Access Compliance Report

Public Rights-of-Way

Intersection ID: 45738	Main Street: PACIFIC_ECHO_DR	Cross Street: PRESCOTT_HILL_AV	Location: SW
ADA ID: 303B54975861	Ramp Type: PerpDiag	Initial Pass/Fail: Fail	Overall Compliance: No
Severity Score: 8.75			
Codes/Mitigation Info/Possible Solution		Field Measurements/Component Compliance

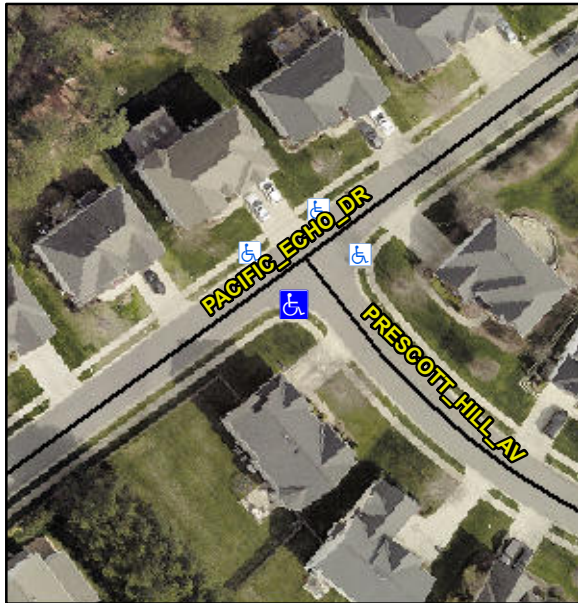
Not Found, R304.5.1

Compliance	Description	Data	Compliance	Description	Data
N/A	Ramp Length (in)	48.0	Yes	Ramp Slope (%)	6.0
No	Ramp Width (in)	45.5	Yes	Ramp XSlope (%)	1.8
N/A	Flare Type LT	N/A	N/A	Flare Type RT	N/A
N/A	Flare Slope LT (%)	N/A	N/A	Flare Slope RT (%)	N/A
N/A	Flare Traversable LT?	N/A	N/A	Flare Traversable RT?	N/A
N/A	Landing Length (in)	N/A	N/A	DWS Provided?	N/A
N/A	Landing Width (in)	N/A	N/A	DWS Contrast?	N/A
N/A	Landing Slope (%)	N/A	N/A	DWS Length (in)	N/A
N/A	Landing X Slope (%)	N/A	N/A	DWS Full Width?	N/A
N/A	Landing Curb? (Y/N)	N/A	N/A	DWS Offset (in)	N/A
N/A	Shared Landing?	N/A			
N/A	Gutter Ponding?	N/A	N/A	Gutter Slope (%)	N/A
N/A	Gutter Lip Ht (in)	N/A	N/A	Gutter X Slope (%)	N/A
N/A	Painted X Walk1?	No	N/A	Painted X Walk2?	No
	X Walk 1 Direction	To NE		X Walk 2 Direction	To NW
N/A	X Walk 1 Width (in)	N/A	N/A	X Walk 2 Width (in)	N/A
	X Walk 1 Slope (%)	5.2		X Walk 2 Slope (%)	3.5
	X Walk 1 X Slope (%)	2.1		X Walk 2 X Slope (%)	5.7

Remove & Replace Curb Ramp With Two New Directional Ramps or Equivalent.
